Work Order ID 103587

Item ID: D212-664-101 Accept \*N9000040100\* Setup Start \*NS1\*  
 Revision ID: Stop \*NS2\*  
 Item Name: Fwd Crosstube - High  
 Start Date: 6/24/13 Start Qty: 1.00 \*1\* Cust Item ID:  
 Required Date: 7/05/13 Req'd Qty: 1.00 \*1\* Customer:  
 Reference:

DRAWING NO. D212-664-141	TITLE XTUBE ASSY (205/212/412 HI FWD)	REV. D	DART AEROSPACE LTD ENGINEERING ORDER		D.E.O. NO. D212-664-141-D-1	SHEET NO. SHEET 1 OF 2	SCALE NTS
DRAWN	CHECKED	MFG. APPR.	APPROVED	DE APPR.			
DATE 11.04.07	DATE 11.04.11	DATE 11.04.12	DATE 11/04/12	DATE 11.04.12

DRAWING NO. D212-664-141	TITLE CROSSTUBE ASS'Y (205 HI FWD)	REV. D	<b>DART AEROSPACE LTD ENGINEERING ORDER</b>		D.E.O. NO. D212-664-141-D-2	SHEET NO. SHEET 1 OF 1	SCALE NTS
DRAWN <i>UP</i>	CHECKED <i>ASS</i>	MFG. APPR. <i>AB</i>	APPROVED <i>MD</i>		DE APPR. <i>TH</i>		
DATE 11.07.15	DATE 11.07.20	DATE 11.07.21	DATE 11/07/21		DATE 11.07.21

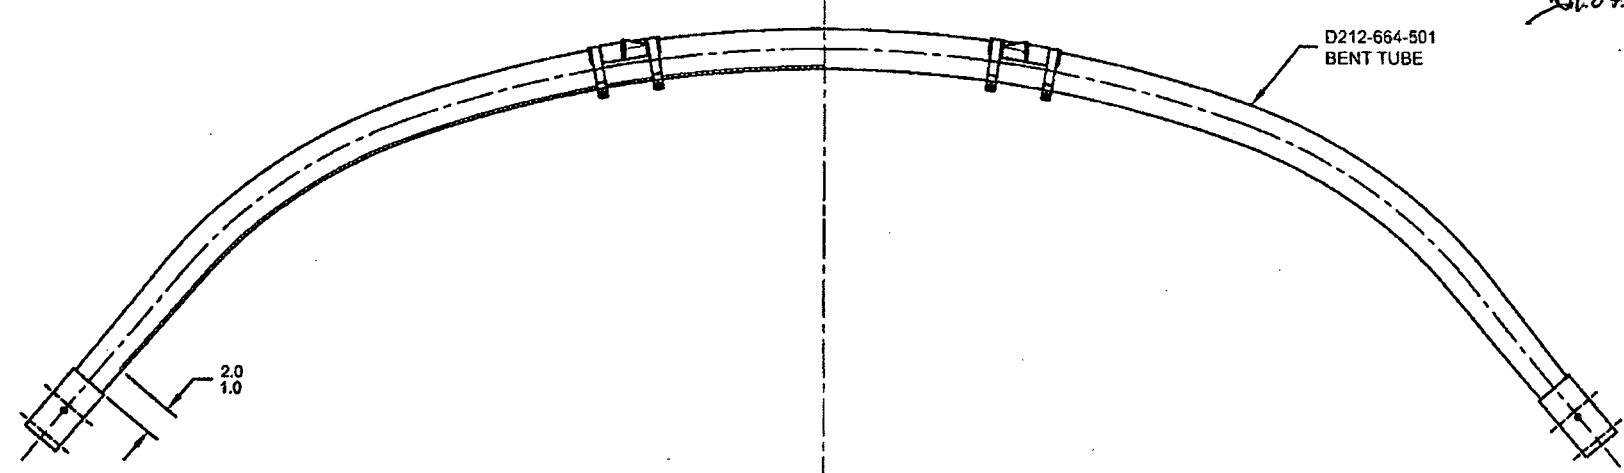
ADD AN INSPECTION WINDOW TO UNDERSIDE OF CROSSTUBE.

NOTES 2 OF SHEET 1 IS AMENDED AS FOLLOWS:

- 2) FINISH: CHEMICAL CONVERSION COAT PER DART QSI 005 4.1  
PRIME INSIDE AND OUTSIDE PER DART QSI 005 4.2  
MASK UNDERSIDE OF CROSSTUBE AS SHOWN (HATCHED AREA) AND  
PAINT OUTSIDE PER DART QSI 005 4.2  
REMOVE MASKING AND APPLY CLEAR COAT

**D212-664-141/-141B  
ASSEMBLY DETAIL**

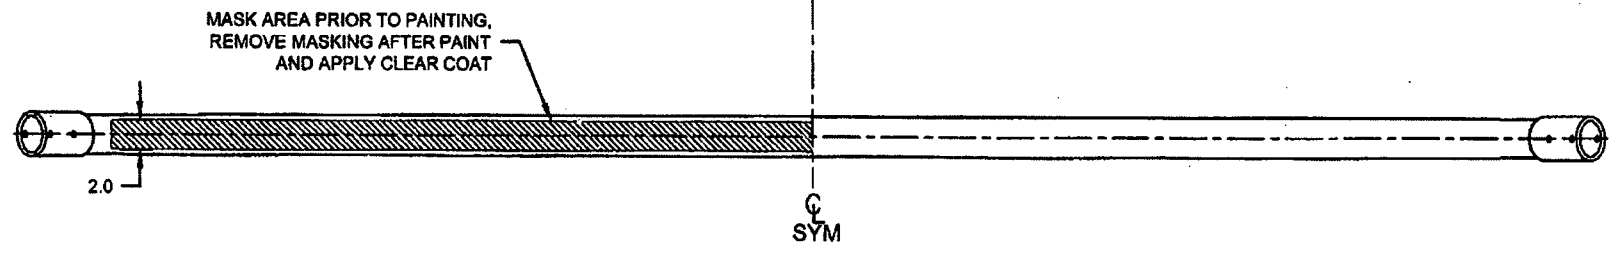
REPLACE MAGNOBOND WITH PROSEAL.

NOTE 12 &amp; 15, SHEET 1 IS AMENDED AS FOLLOWS:

- 12) TO INSTALL D2893-1 SUPPORT: ABRASE MATING SURFACE OF SUPPORT AND CROSSTUBE WITH 180-GRIT SANDPAPER AND REMOVE RESIDUE WITH MEK (OR EQUIVALENT). APPLY A 0.04" TO 0.07" THICK LAYER OF PROSEAL 890 CLASS B-2 (OR AMS-S-8802 CLASS B-2) SEALANT TO MATING SURFACE OF SUPPORT.
- 15) TORQUE CLAMPS 80 TO 100 IN-LB. ENSURE AT LEAST 1.5 THREADS SHOWING IN SAFETY AND THAT NUT HAS NOT BOTTOMED-OUT AFTER TORQUING. **PRIOR TO PACKAGING, RE-CHECK TORQUE ON CLAMPS AFTER PROSEAL 890 SEALANT HAS CURED FOR 72 HOURS.**
